STATE OF ALASKA
DEPARTMENT OF TRANSPORTATION AND PUBLIC FACILITIES

Hoonah Alaska

GENERAL LAYOUT

PROJECT NUMBER X 70006 SHEET 2 OF 6

V22/B5	AS BUILT 1-14-86		
STAMP	DO NOT SCALE THIS DRAWING - USE DIMENSIONS		
	STATE OF ALASKA		
	DEPARTMENT OF TRANSPORTATION AND PUBLIC FACILITIES		
	Hoonah	Alaska	
MISC. DETAILS			
DESIGNED LJB	CHECKED JS	DRAWN LJB	DATE 10/84
PROJECT NUMBER X70006	SHEET 4		OF 6

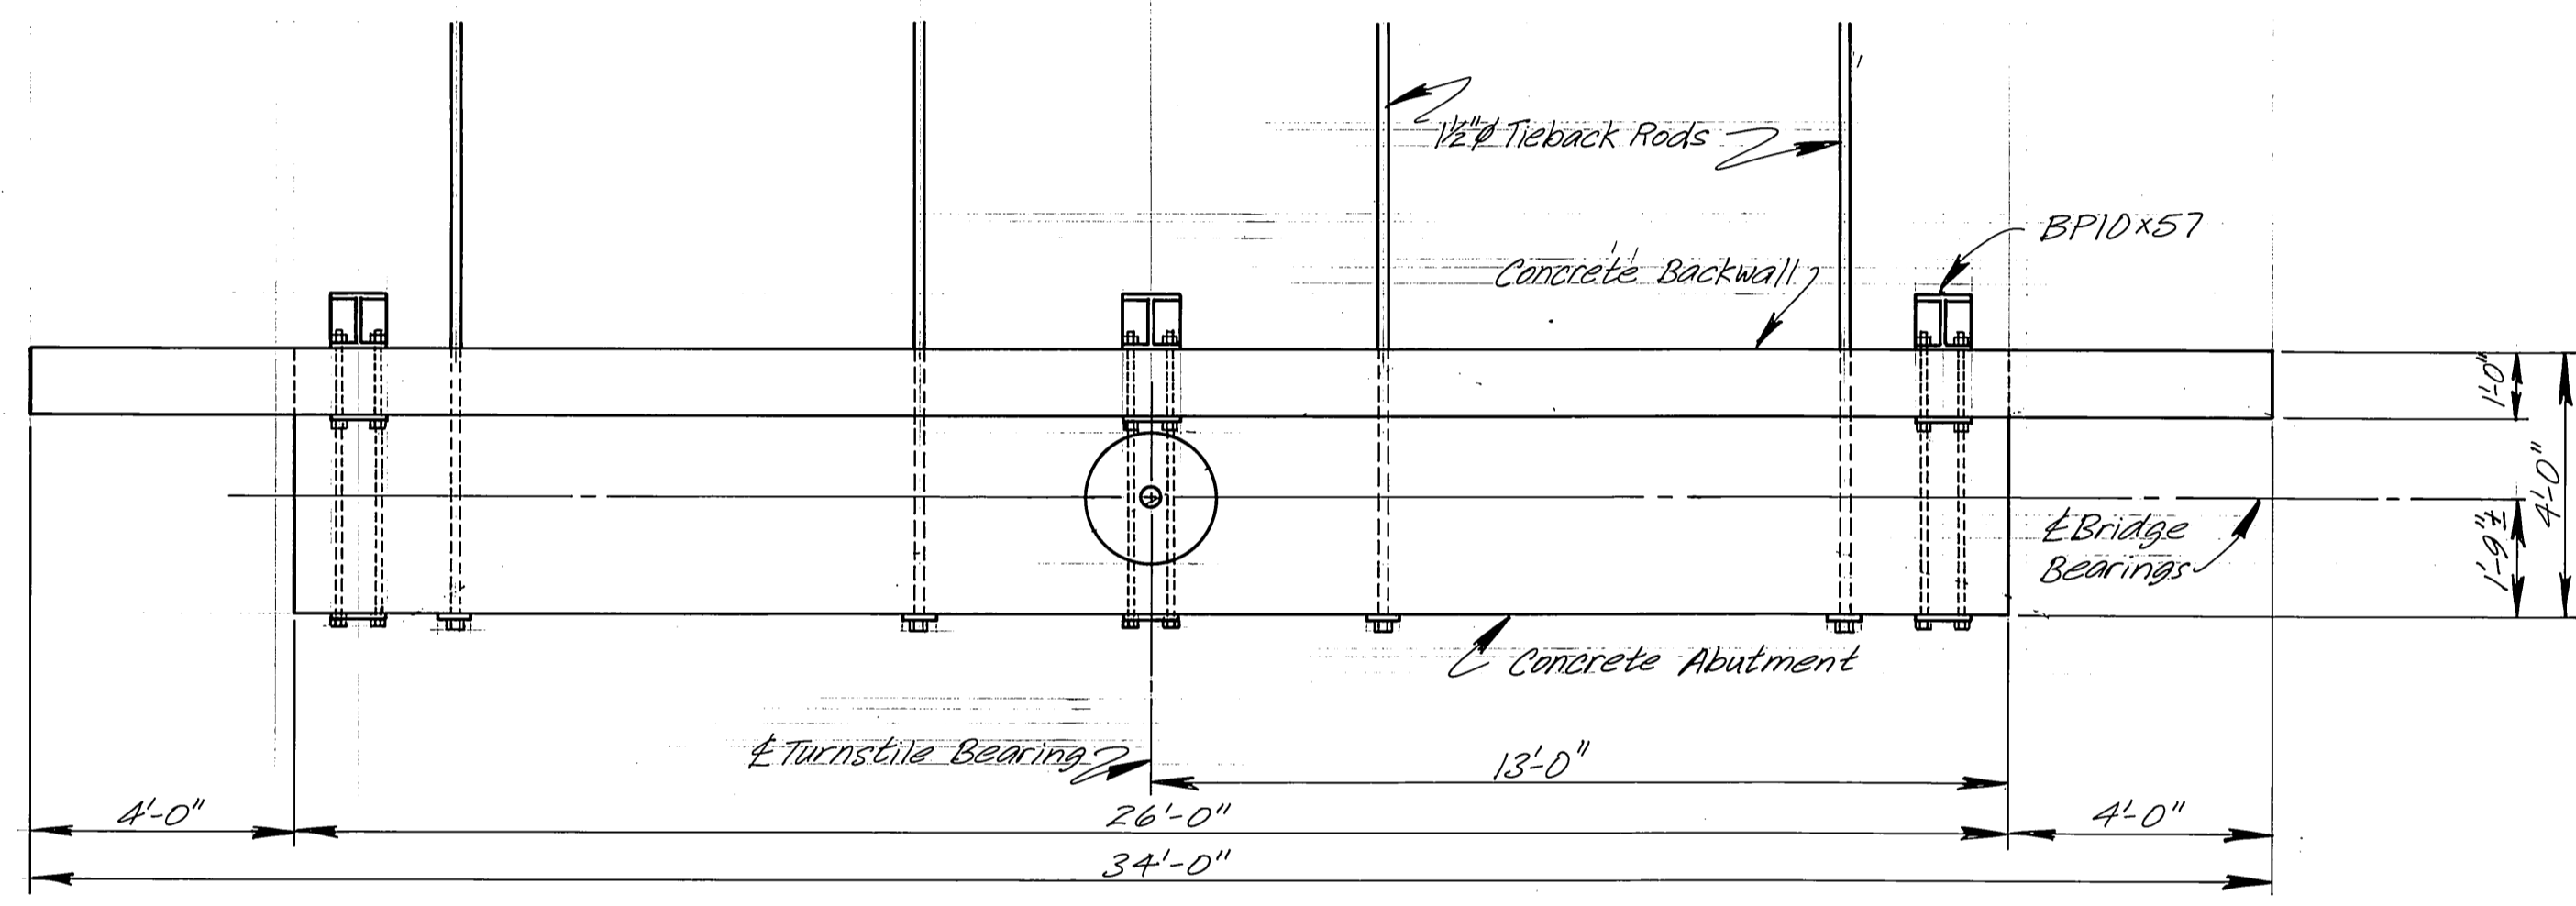
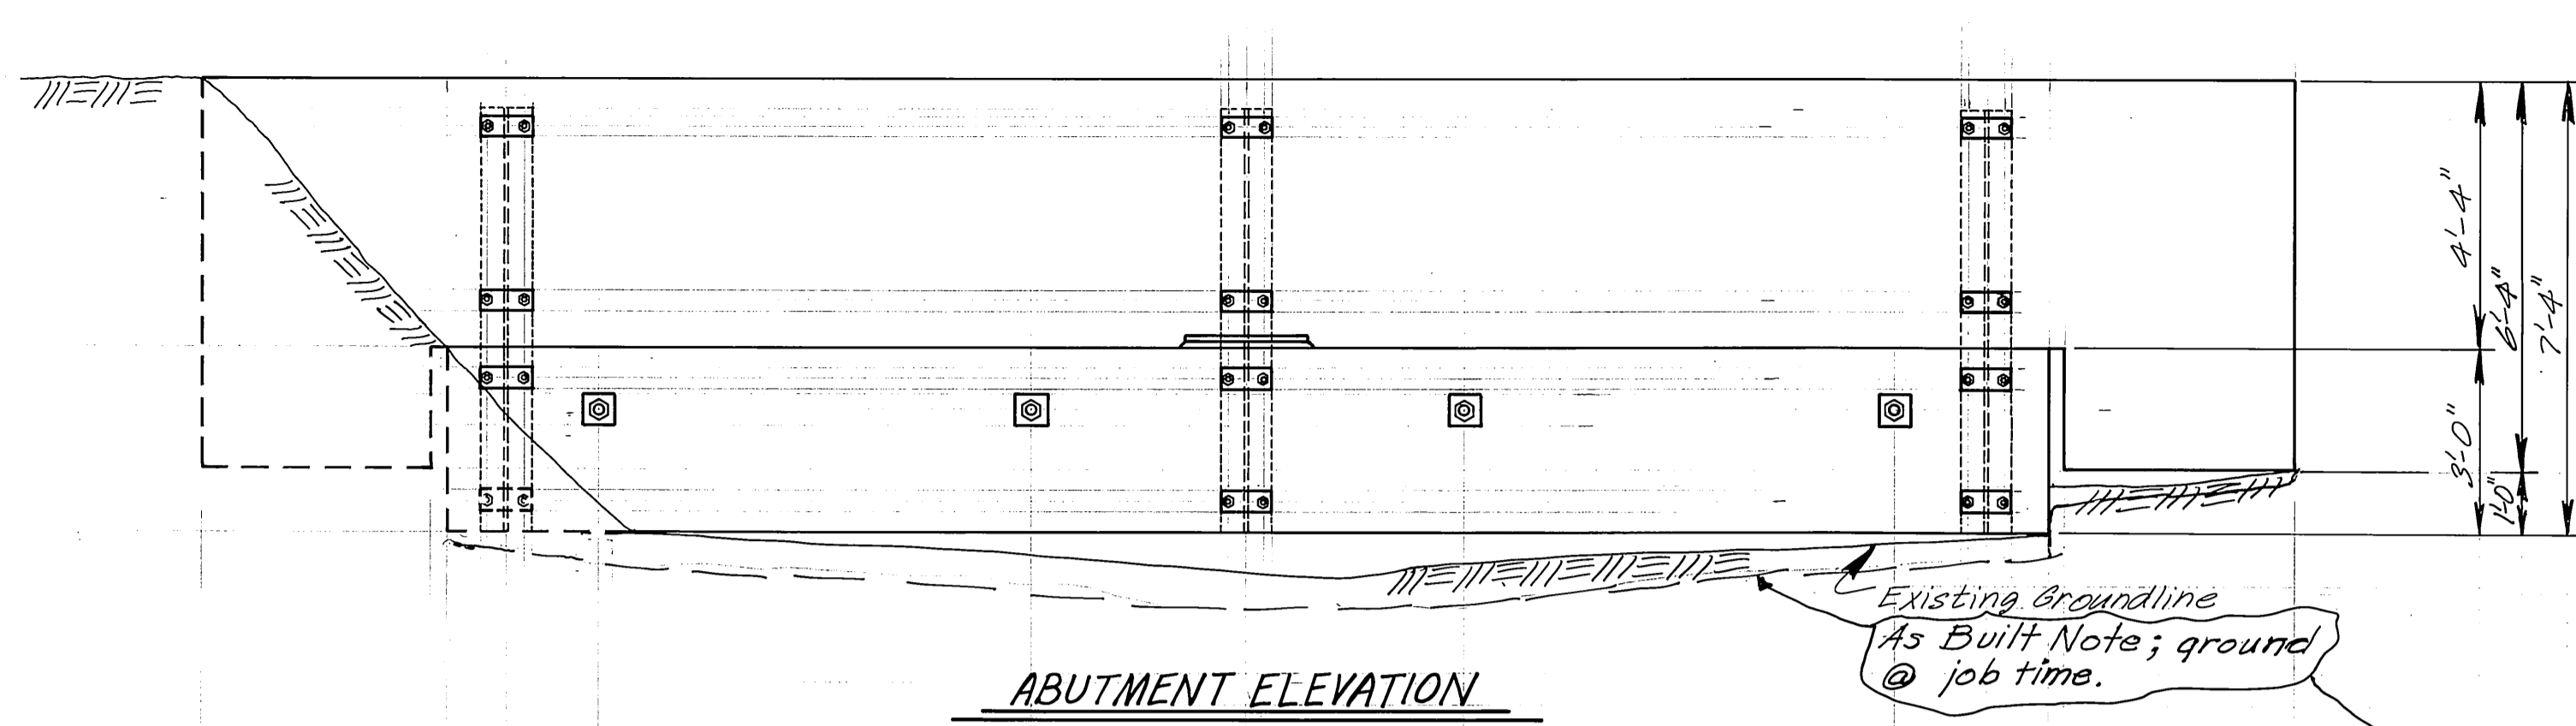
As Built Note: By job time too much erosion had occurred to use grout, therefore forms were built and concrete was poured.
